LCR# 85-07

ATTACHMENT A

MARKED-UP SALEM FSAR SECTION 15.4.8.2
STEAMLINE BREAKS

FIGURE 15.4-97

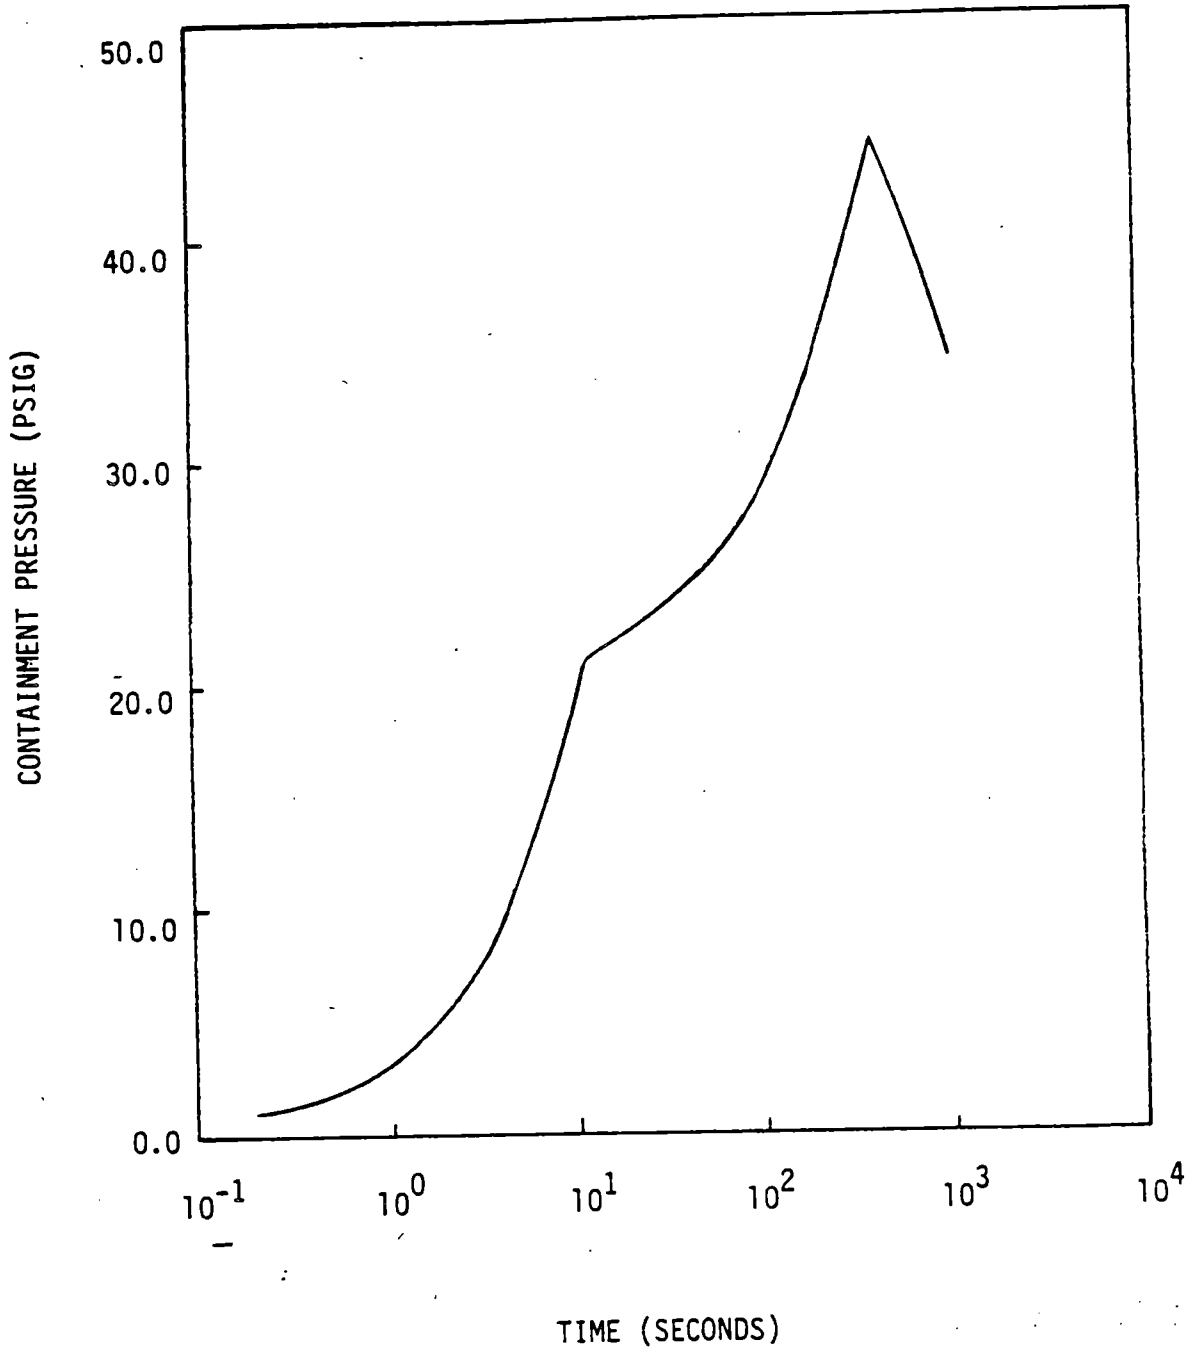
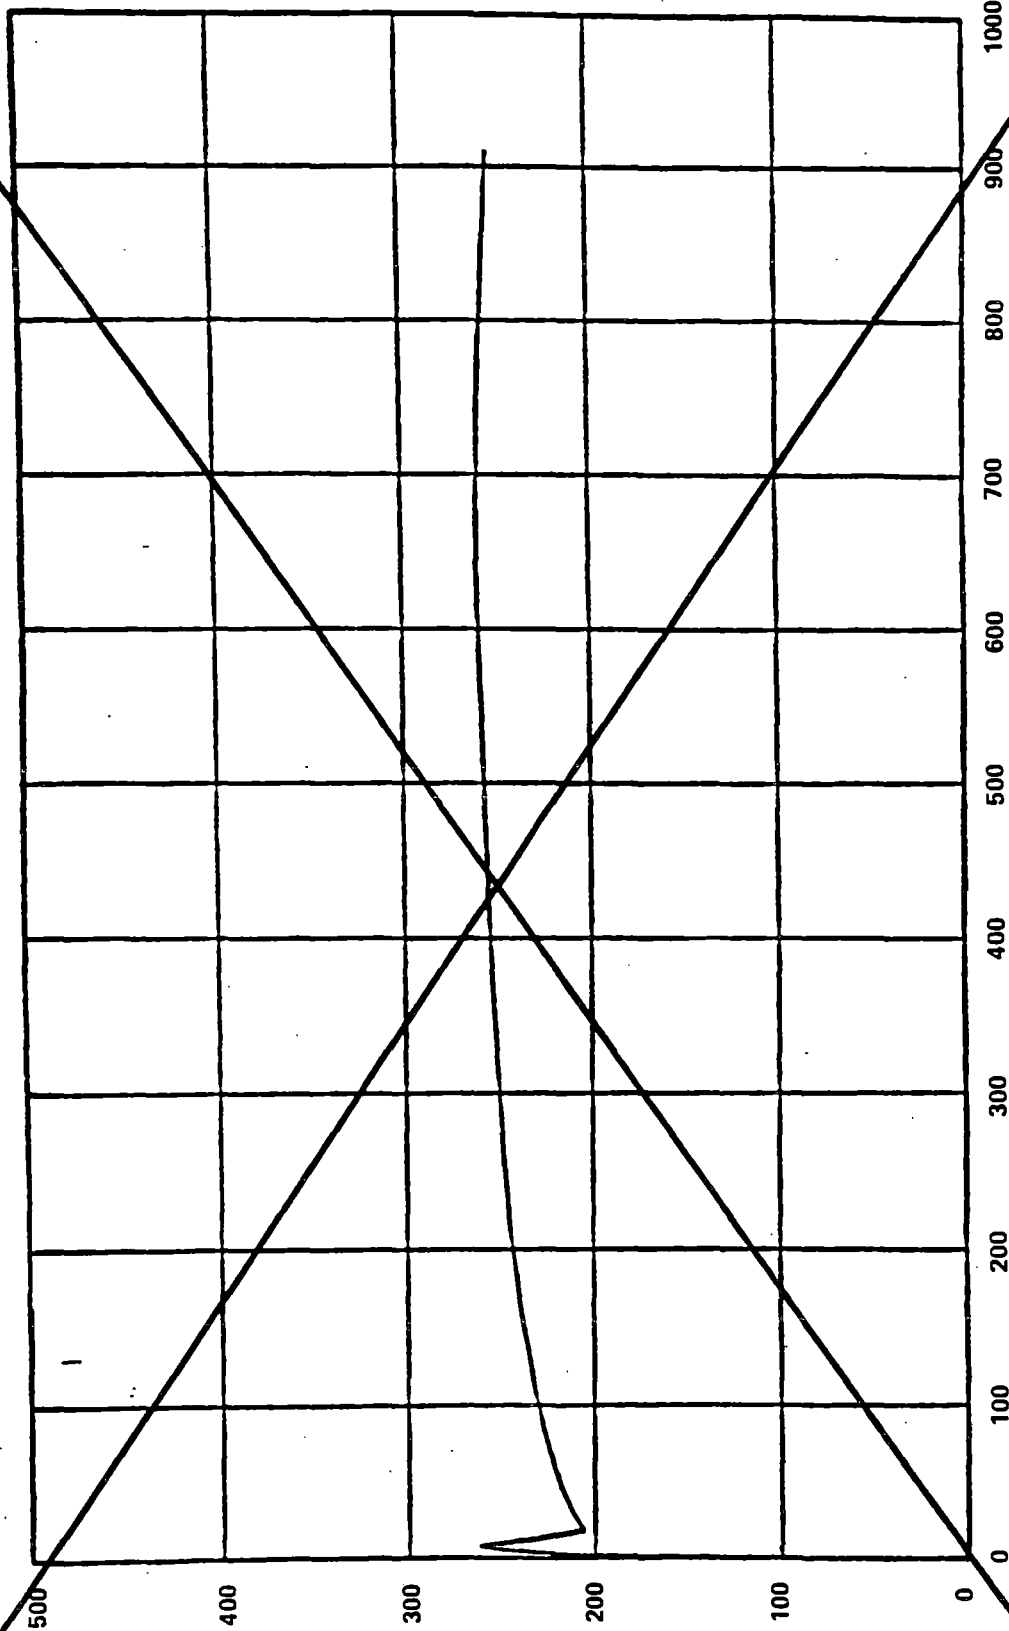
Replace w/ next sheet

FIGURE 15.4-98

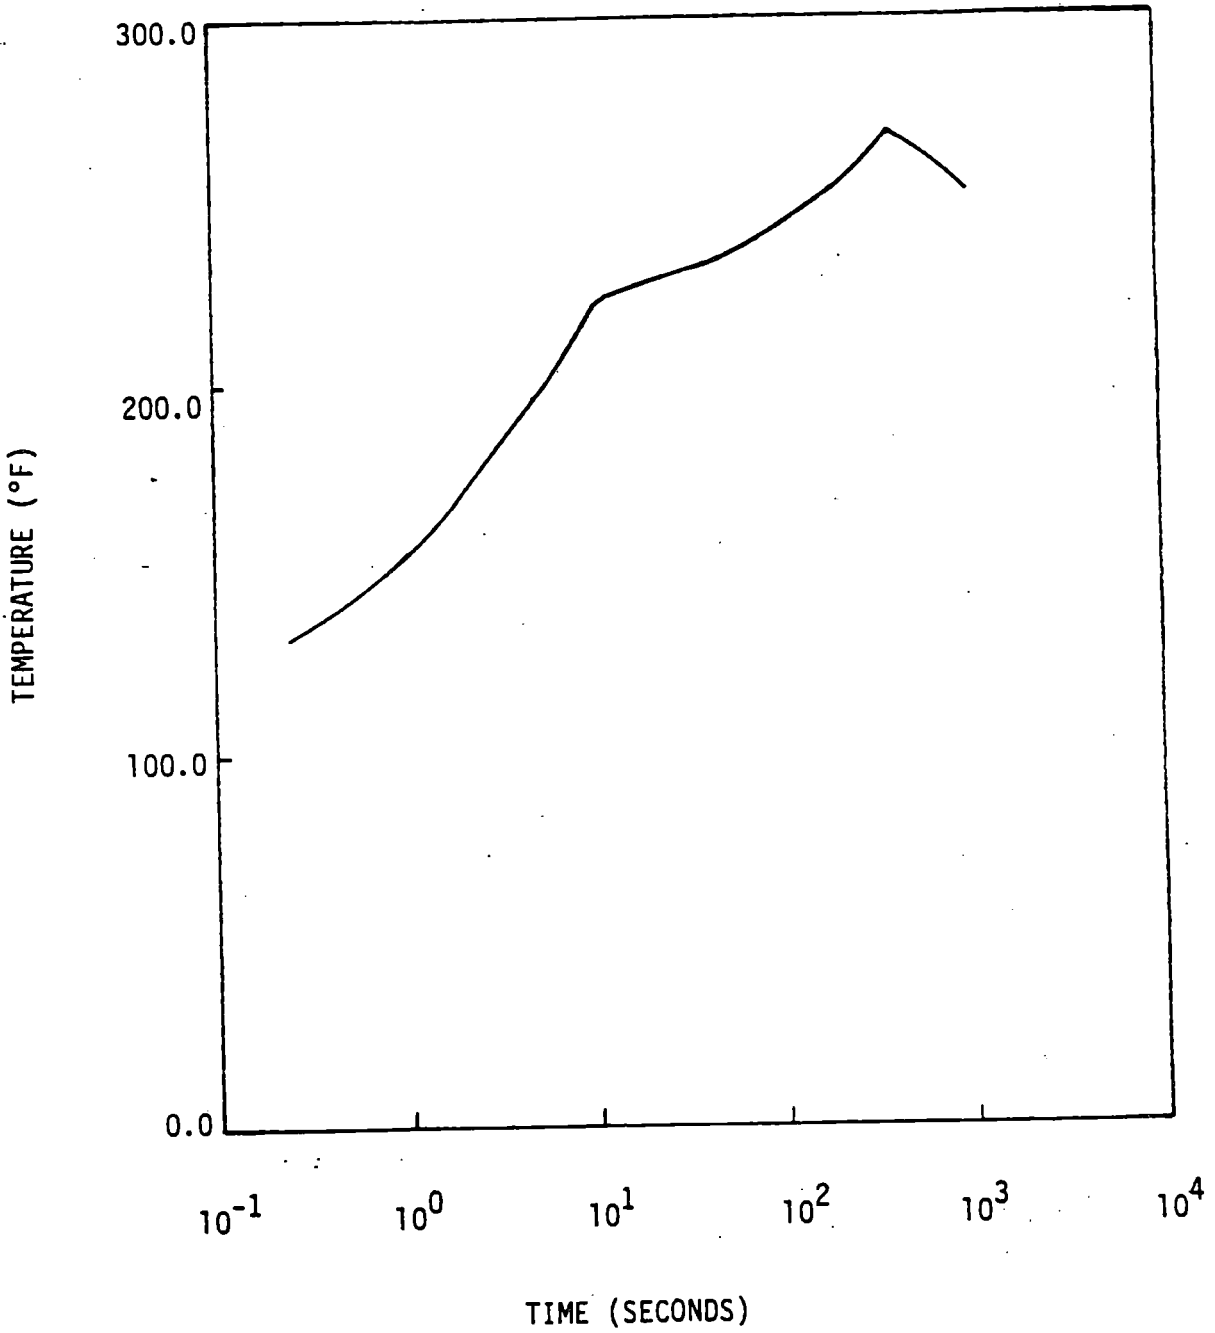
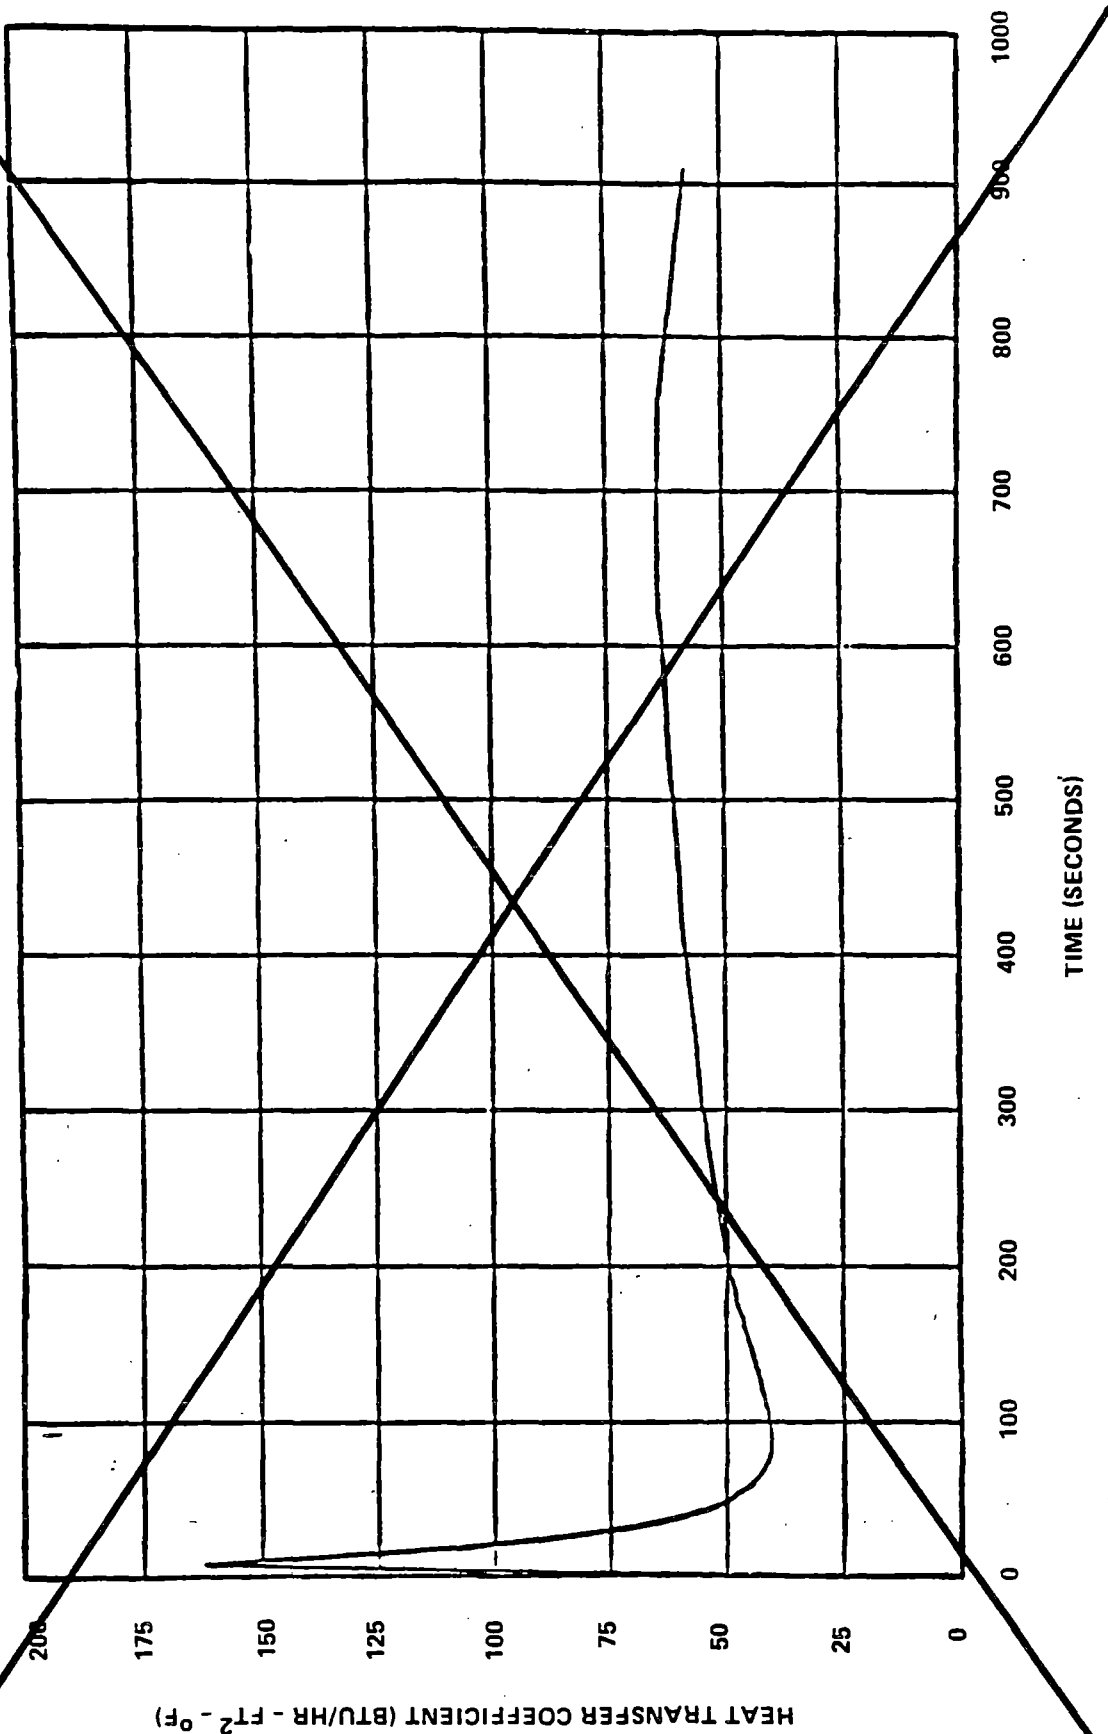
Replace w/ next sheet

FIGURE 15.4-99

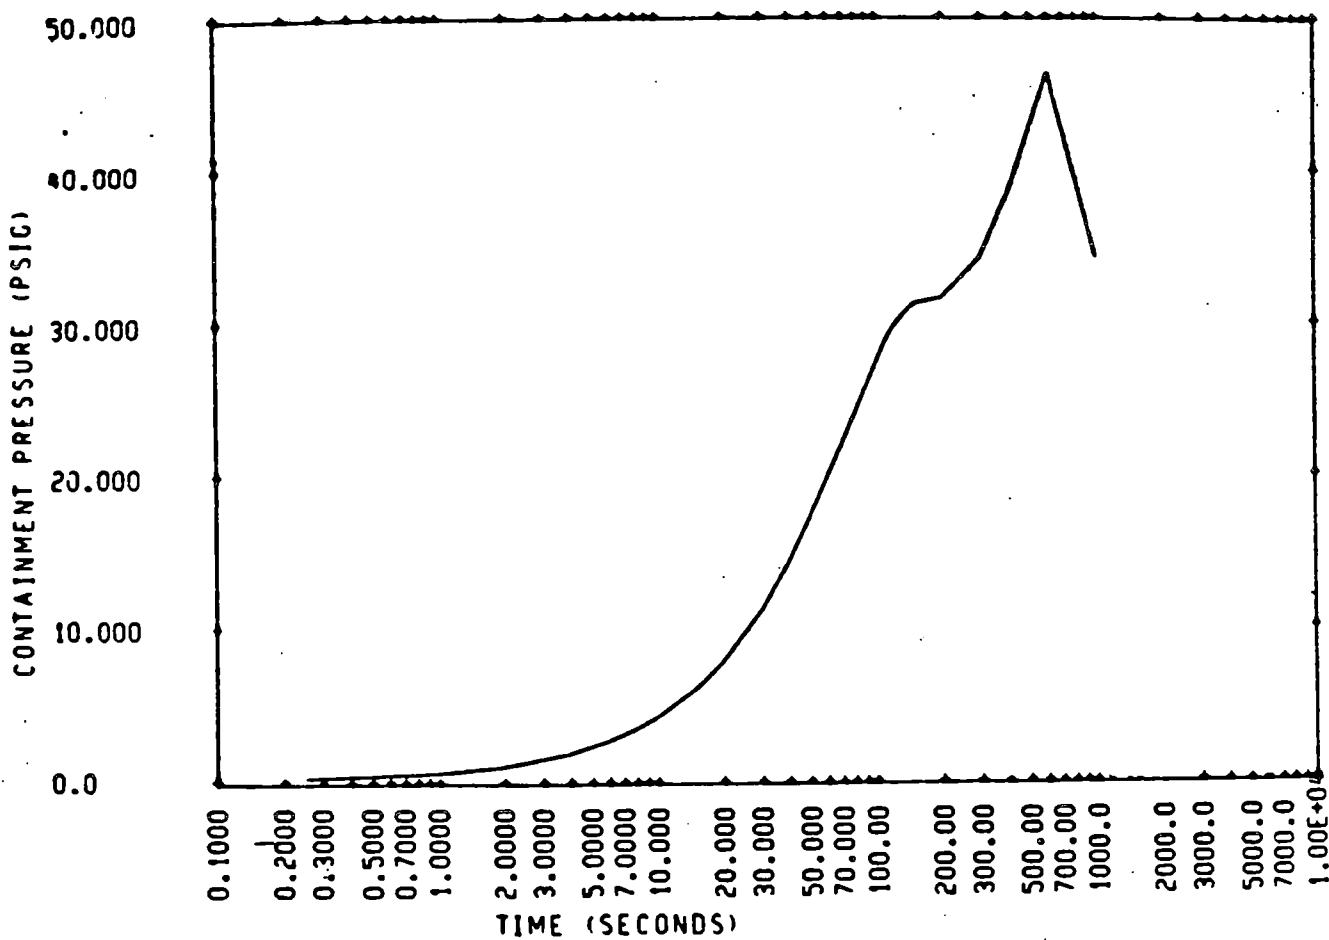
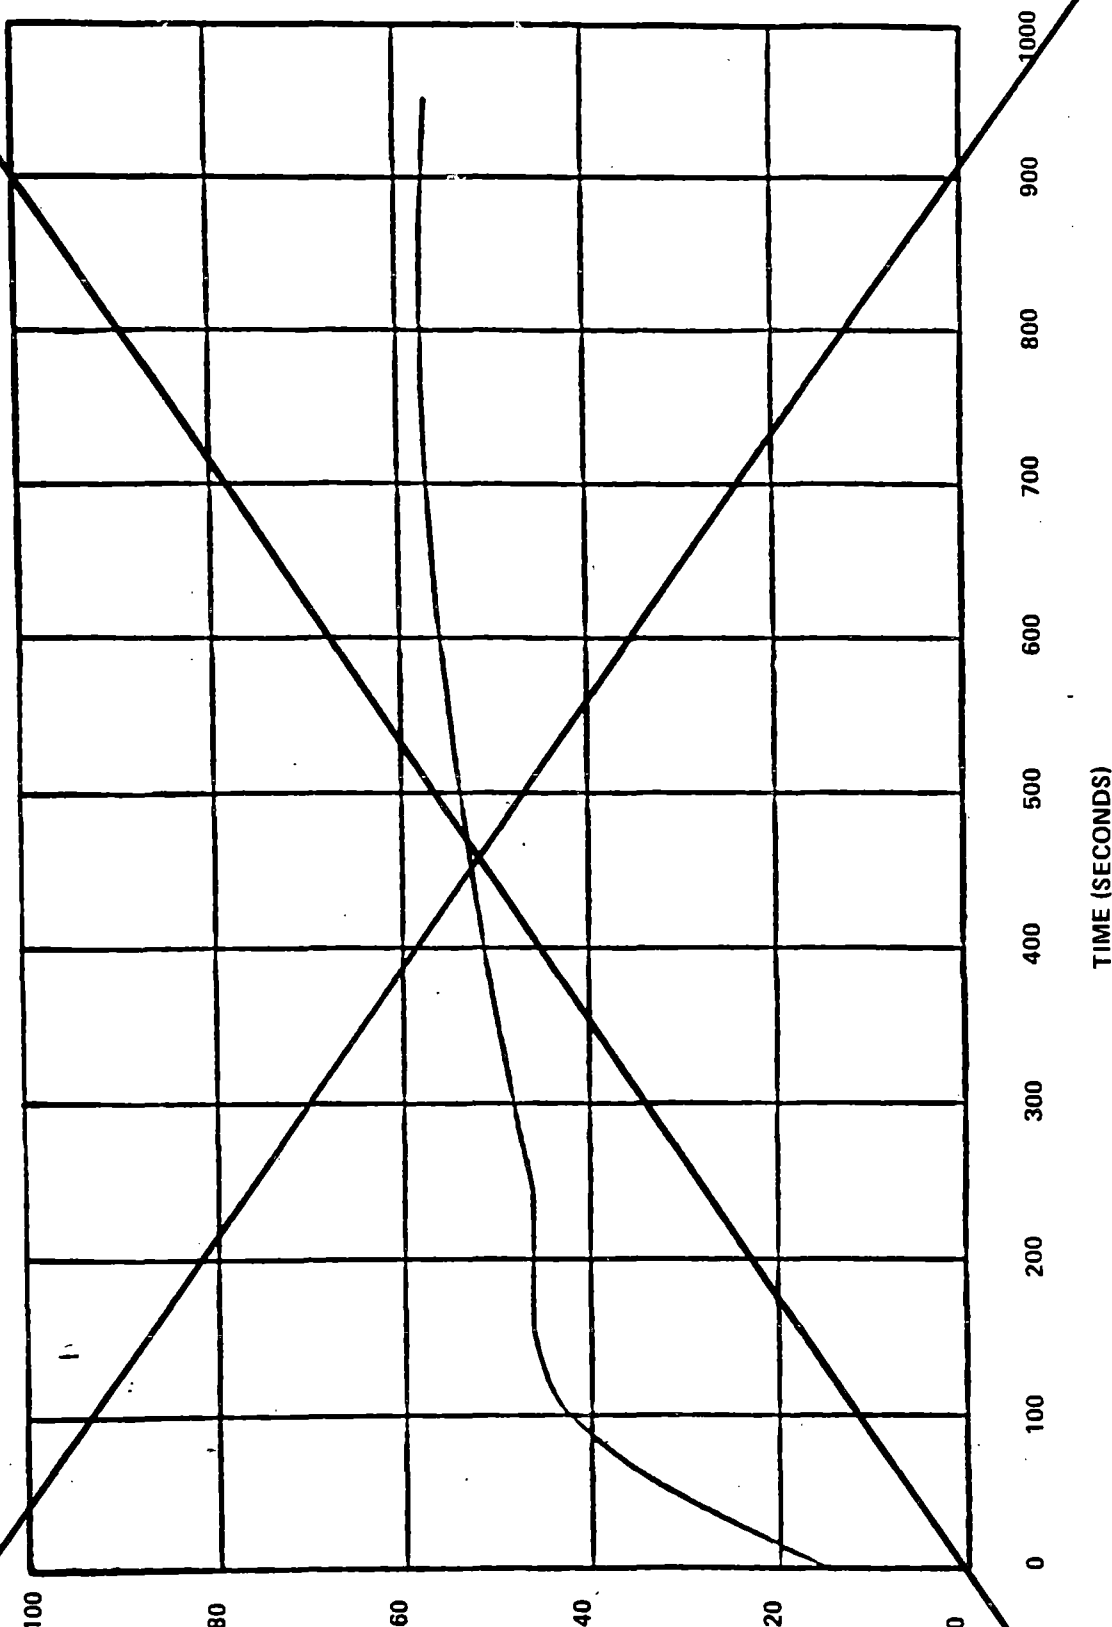
Replace w/ next sheet
